South Texas Project Electric Generating Station P.O. Box 289 Wadsworth, Texas 77483

August 19, 2010  
U7-C-STP-NRC-100193

South Texas Project  
Units 3 and 4  
Docket Nos. 52-012 and 52-013  
Revised Response to Request for Additional Information

**RAI 03.08.04-18, Revision 1, Supplement 1****QUESTION:****Follow-up to Question 03.08.04-2 (RAI 2964)**

FIGURE 12.3-37 RADWASTE BUILDING, RADIATION ZONE MAP, NORMAL OPERATION AT ELEVATION -1700 MM

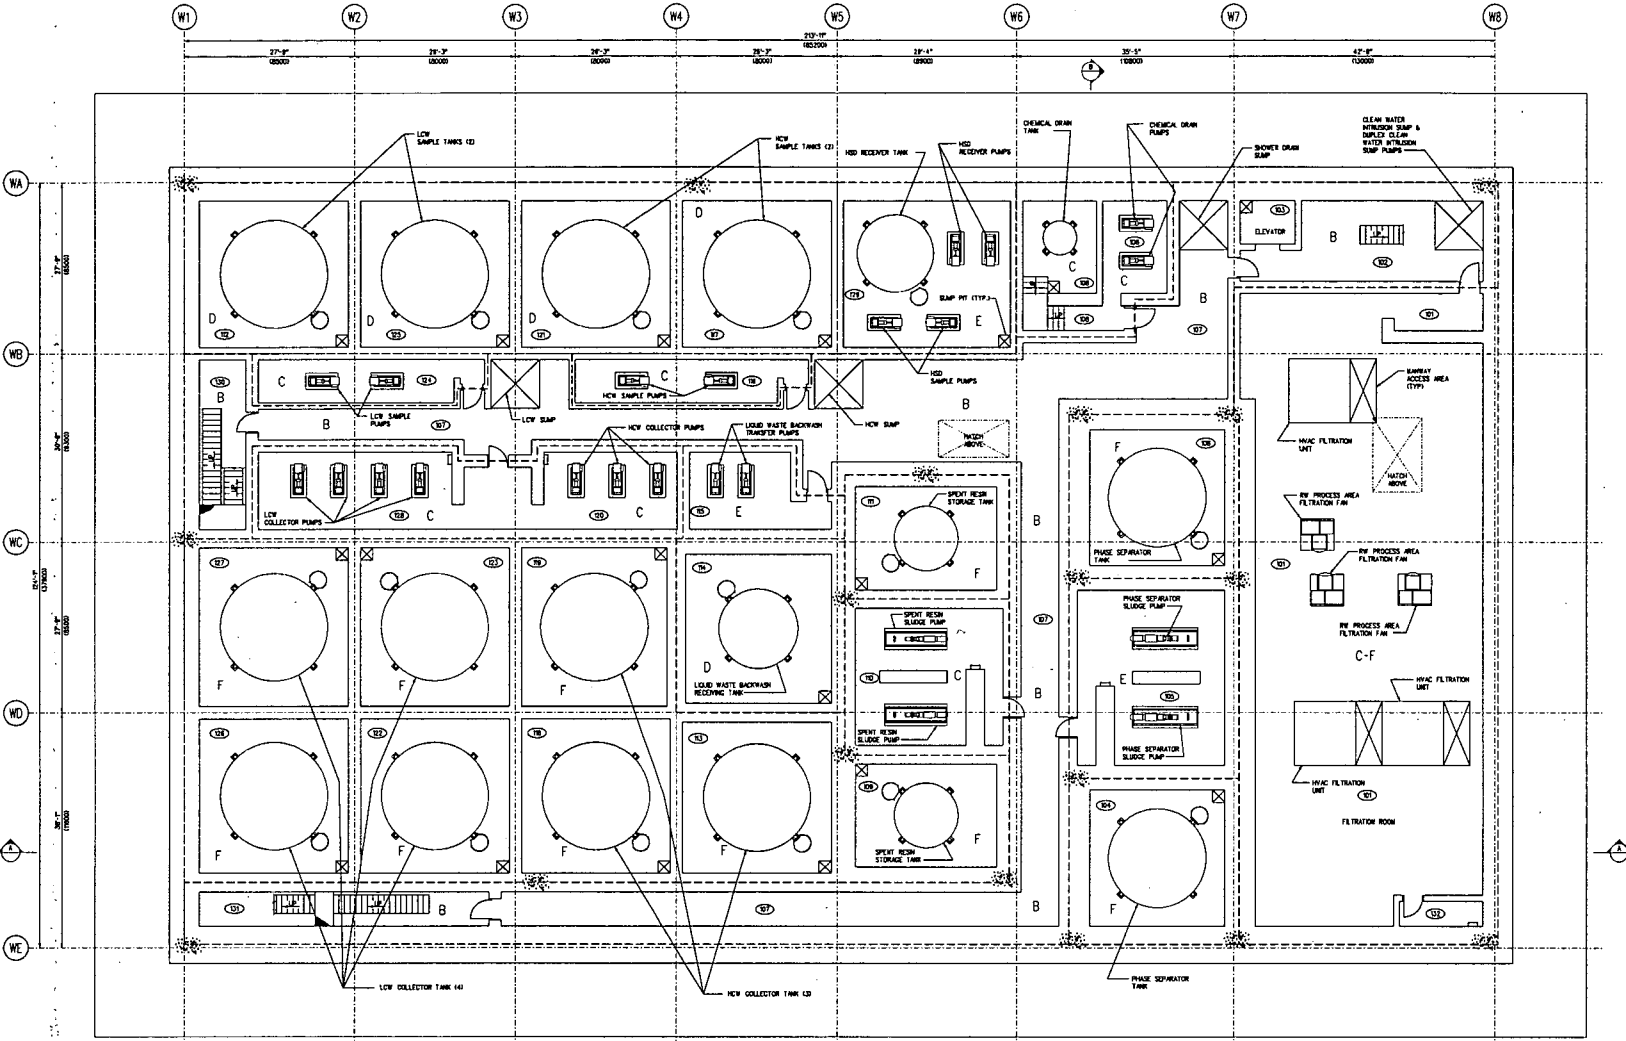
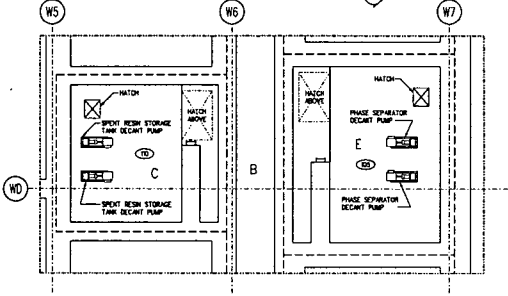
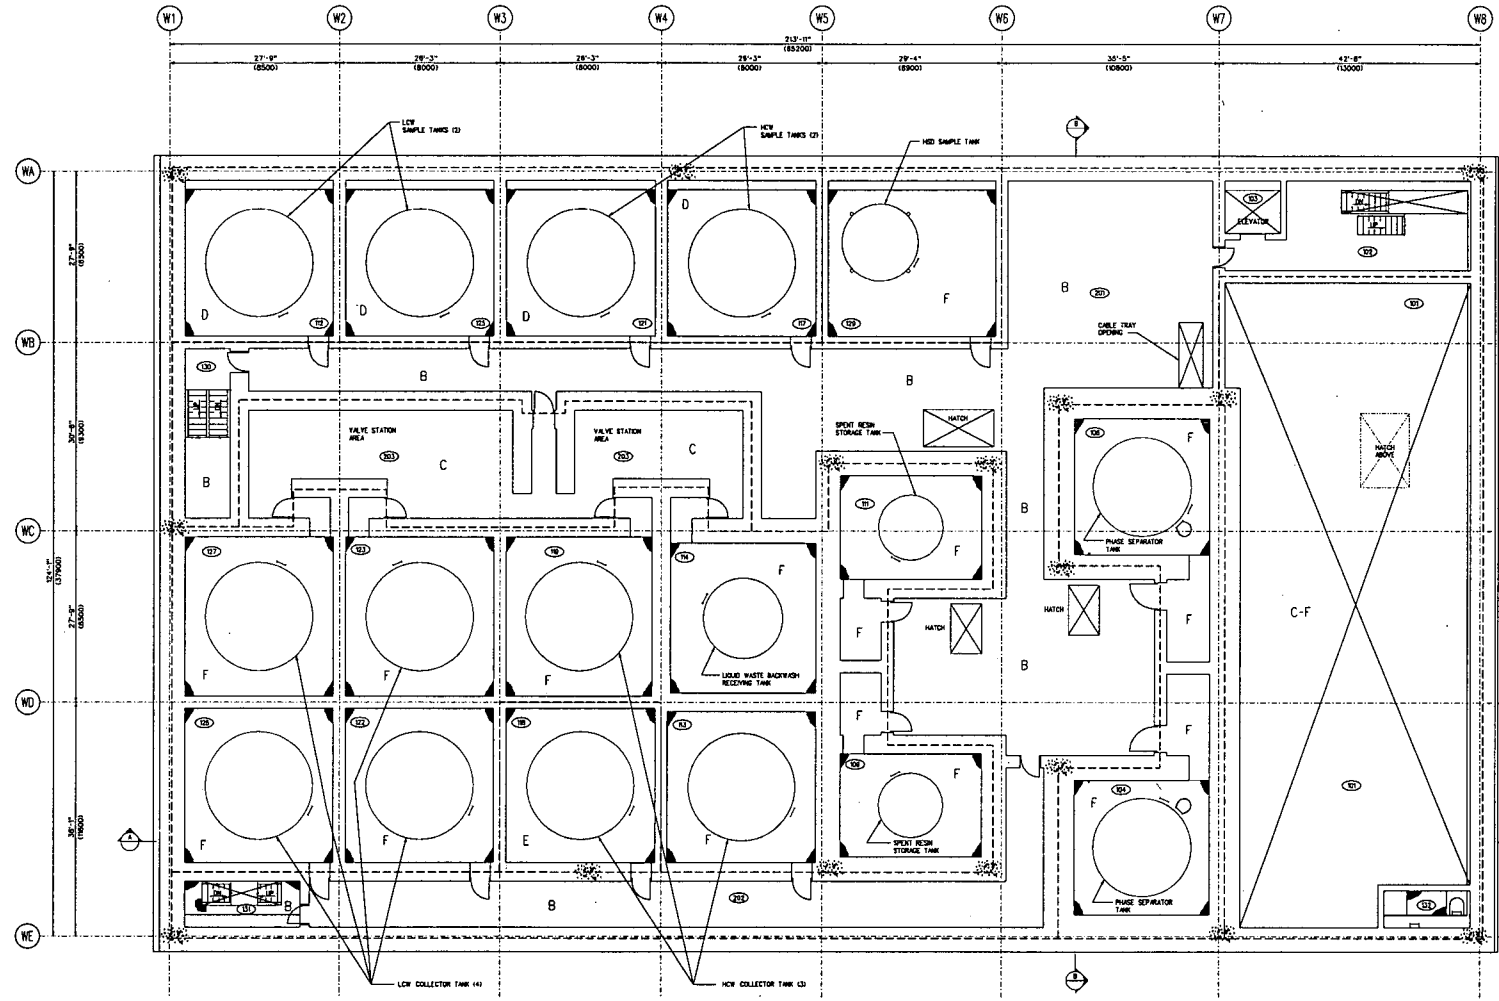
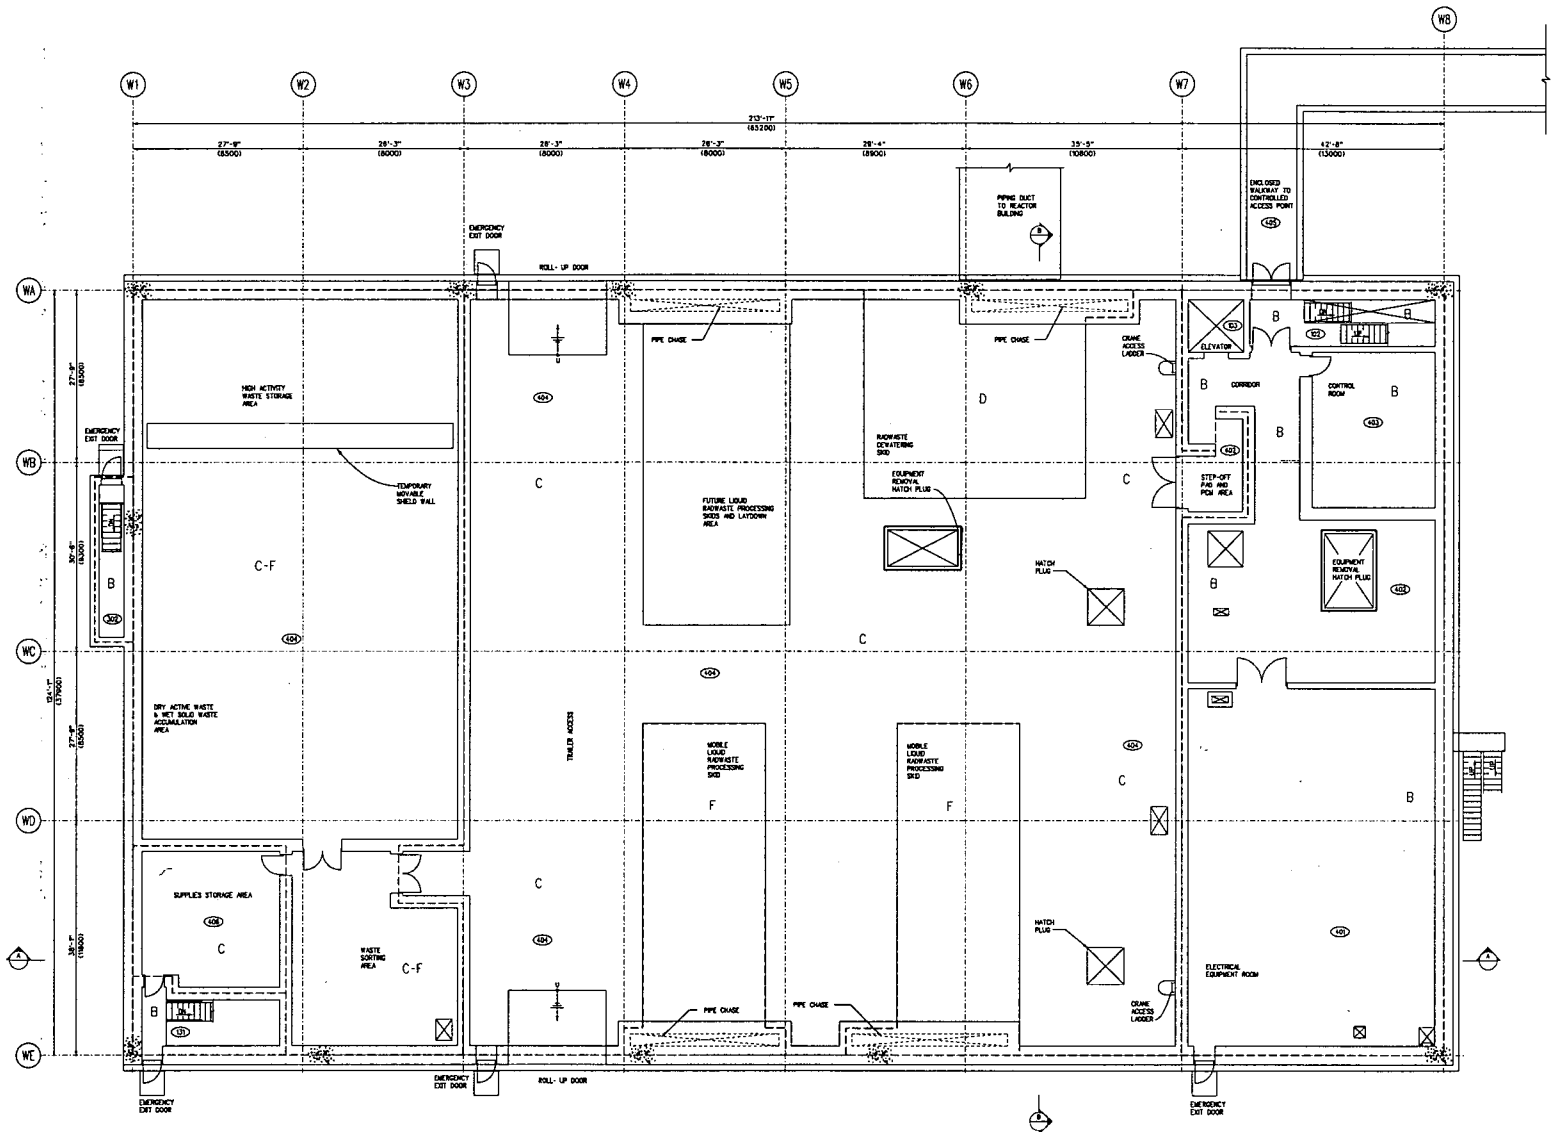
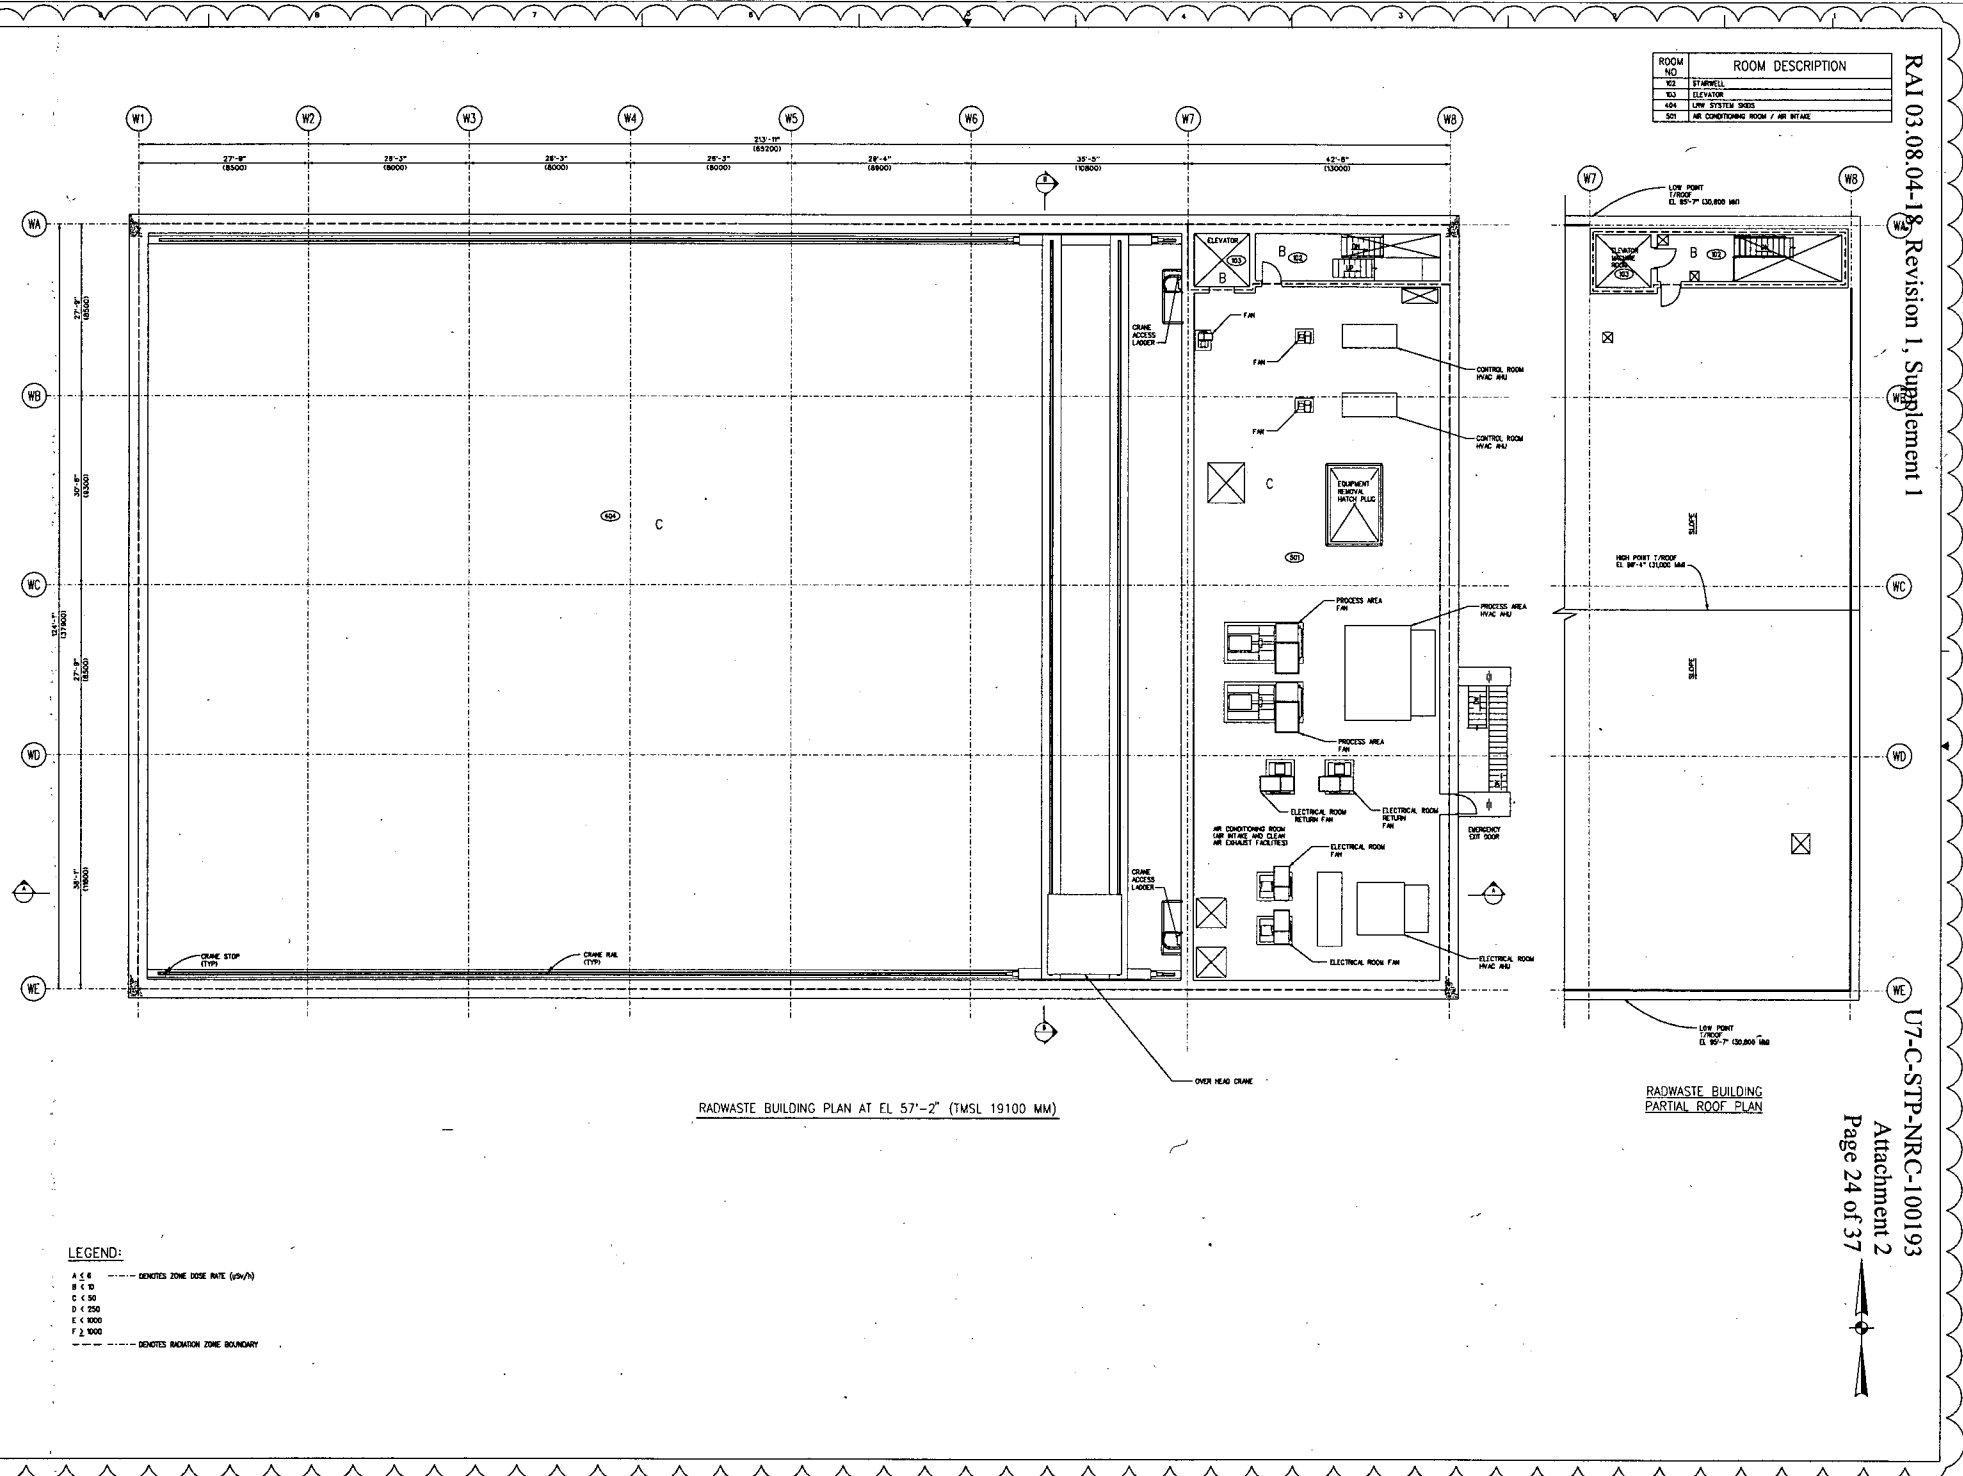
#### **Radiation Zone Maps (Figures 12.3-37 through 12.3-41)**

The changes in the arrangement shown on the RWB GAs do not result in any changes to the radiation zone designations for the various areas (equipment rooms, pipe chases, hallways, etc) in the RWB. The radiation sources in the individual rooms remain the same (i.e., the room and the source in it are moved), and the shielding is adjusted as necessary to ensure the radiation levels in protected areas correspond to the established radiation zone (the shield wall thickness changes are associated with situations where the area outside of the room has a different radiation zone). The changes in the shielding wall thicknesses are described in the markup of FSAR Table 12.2-5c (see below).
